TOWN OF EAST HAMPTON

April 29, 2021

RE: 80 Firestone Road – Site Plan/Special Permit
SCTM# 300-017-01-05
80 Firestone Road, Montauk
App # A0520160034

DRAWING:
 LANDSCAPE & REVEG PLAN

SHEET NUMBER:
L3.1

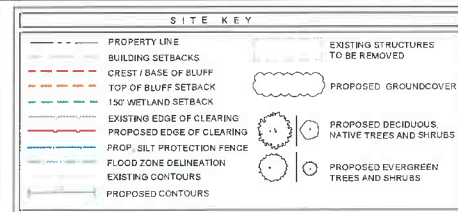
At the time of the last review, the remaining outstanding issue was for the applicants to provide the spacing of bayberry (*Myrica pensylvanica*) within the area of revegetation required by Condition J.4.d of the Zoning Board's determination, which is seaward of the landward limit of the Coastal Erosion Hazard Area (CEHA) boundary. The applicants have submitted a revised Landscape and Re-vegetation plan (Sheet L3.1 dated March 21, 2021 prepared by Christopher LaGuardia – LaGuardia Design Landscape Architecture P.C.). Spacing is to average 4-5' on center which is consistent with Planning Department recommendations. Based on these specifications, the plan is acceptable to the Planning Department. The Board should determine if it agrees

REVISIONS:
 March 7, 2021
 Increased qty. of bayberry within the coastal erosion hazard area & subsequently reduced qty. of little bluestem
